ADDENDUM NO. 2

PROJECT NAME: **Huebner Creek Hike and Bike Trail – BID #2022-07**

DATE: June 24, 2022

CONCRETE SIDEWALK SECTION (TYPE B)

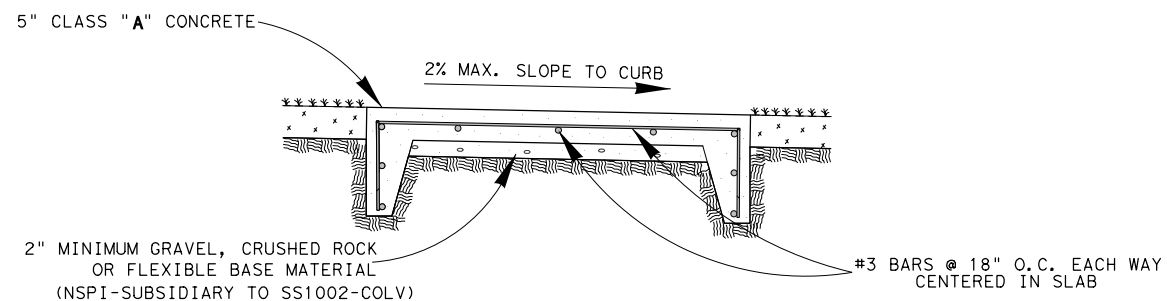
1. Callout for Class A concrete was updated on Concrete Sidewalk Section Typical Section Type B, sheet 7.
2. Concrete quantities were updated on the Base Price Bid Items.

1. CONCRETE SIDEWALK SHOWN SHALL MEET THE MINIMUM SPECIFICATION REQUIREMENTS OF CLASS "A" CONCRETE PER ITEM 531 AND 421.
2. ALL REINFORCING STEEL SHALL BE GRADE 60.
3. GROOVED JOINTS IN THE SIDEWALK SHALL BE AT MAX. SPACING OF 10 FT. AND SHALL HAVE 3/4" EXPANSION JOINTS AT A MAX. SPACING OF 50 FT.
4. WHEN TRANSITIONING FROM TYPE A TO TYPE B SIDEWALK CONSTRUCT AN EXPANSION JOINT.
